Petition No. 1221  
Interrogatories  
Set One  
April 14, 2016

Windham Solar LLC (WS) Responses April 28, 2016

**PLAINFIELD PIKE SOLAR**  
 91 PLAINFIELD PIKE RD  
 PLAINFIELD, CT 06374  
 WINDHAM COUNTY

**OVERALL SITE PLAN**

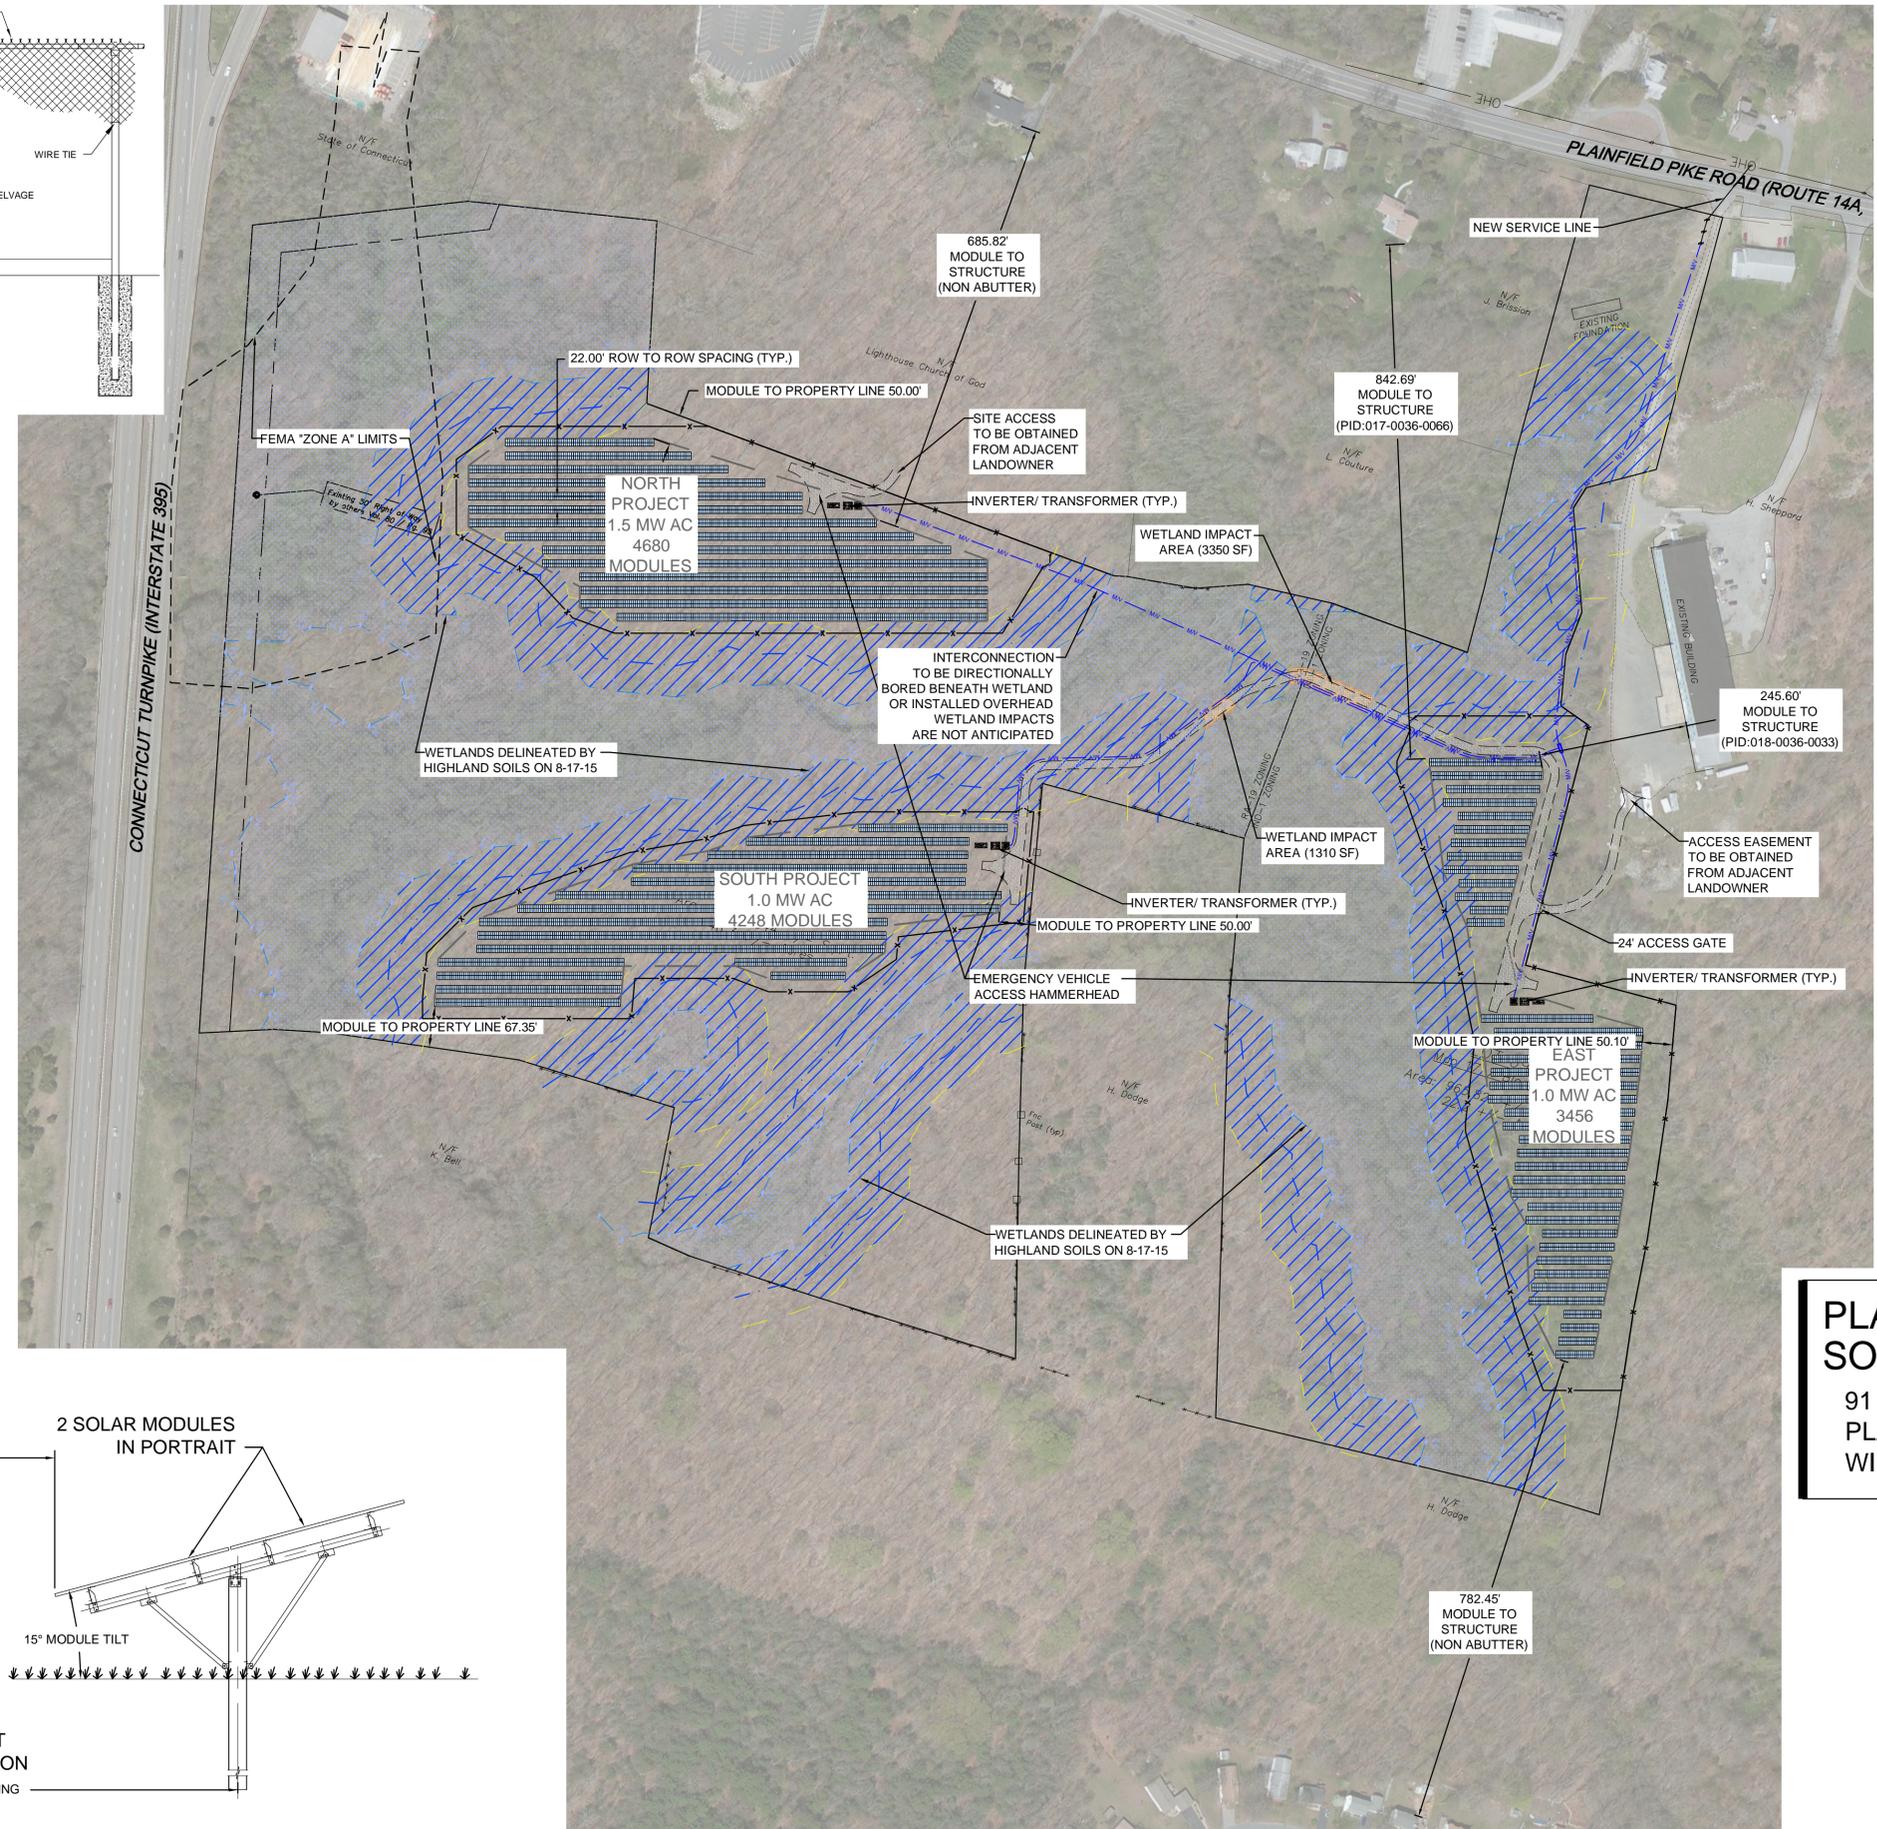
**A revised Map has been attached identifying parcels, and the associated owners. – Exhibit A**
2. Where is the nearest off-site residence from the center of the eastern portion of the project? Provide the distance, direction, and address of such off-site residence. Where is the nearest off-site residence from the center of the western portion of the project? Provide the distance, direction, and address of such off-site residence.

**Output to the grid is calculated in AC. The AC:DC ratio of the project is 1:1.17.**
4. Indicate which solar arrays on the Overall Site Plan (Sheet 3 of 17) are the 1 MW arrays and which array is the 1.5 MW array.

21. Did the Petitioner attempt to minimize wetland crossings when designing the access drives to each of the three solar arrays? For example, for the center (or southwestern) solar array, could the access to that solar array be shifted to the northwest to reduce the 1,455 square feet of wetland impacts? (See Overall Site Plan – Sheet 3 of 17).

**The overall site plan has been revised to show dimensions from the homes to the closest modules to the facility and parcels are identified. – Exhibit B**

**Boundaries have been added to the overall site plan, illustrating each array area. – Exhibit B**
5. Page five of the Petition indicates that, “Each Facility will consist of approximately 3,395 solar modules (based on a module rating of 345 watts).” How many “Facilities” is the Petitioner referring to? In other words, how many multiples of 3,395 solar modules are proposed? Please provide the number of solar modules for the two 1.0 MW and one 1.5 MW arrays and for the entire proposed project.

**Boundaries have been added to the overall site plan illustrating each array area and total module count. – Exhibit B**

The site visit, and updated wetland report, identifies a brook on the site that has constant flow, the crossing location has been abandoned and WS is exploring other options for accessing the central area of the site. Also the alignment of the access roads have been revised given the site visit to more upland locations and the overall project wetland impact has been reduced to 4660 sf. - Exhibit B

**INVERTER SKID PLAN AND PROFILE**

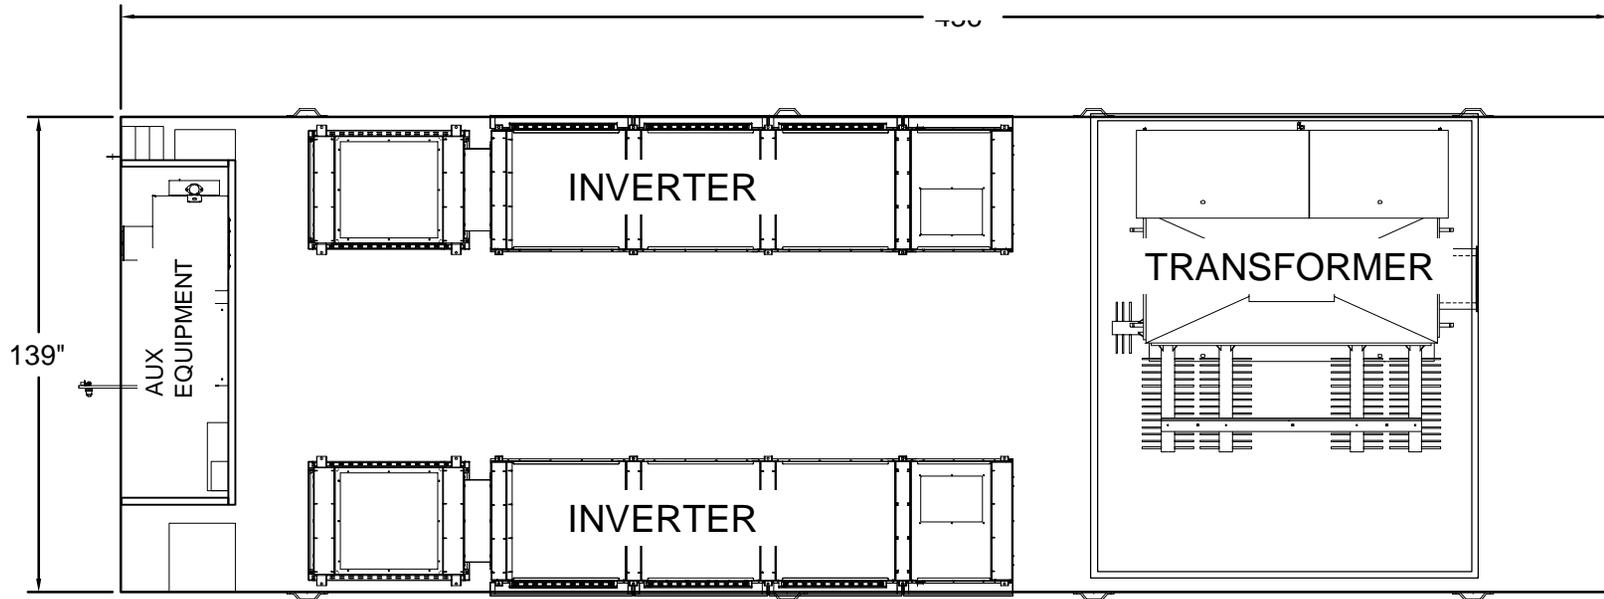
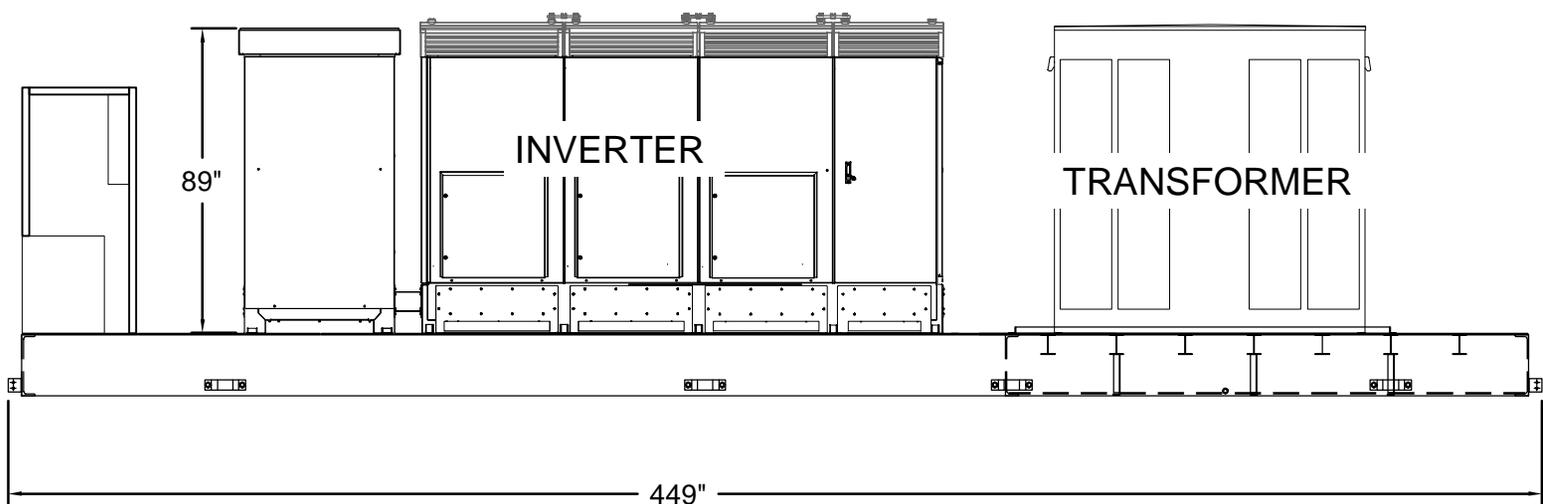
12. What are the estimated heights of the transformers and inverters?

The transformer is approximately 7' high. The 1,000 kW centralized inverter is approximately 7' high. The 60 kW string inverters would be mounted at a height of approximately 5' – 6' high and be located throughout the array field. A cut sheet of a typical inverter/transformer pad has been added (2-1000-kilowatt inverters and 1 2000KvA transformer) – Exhibit E
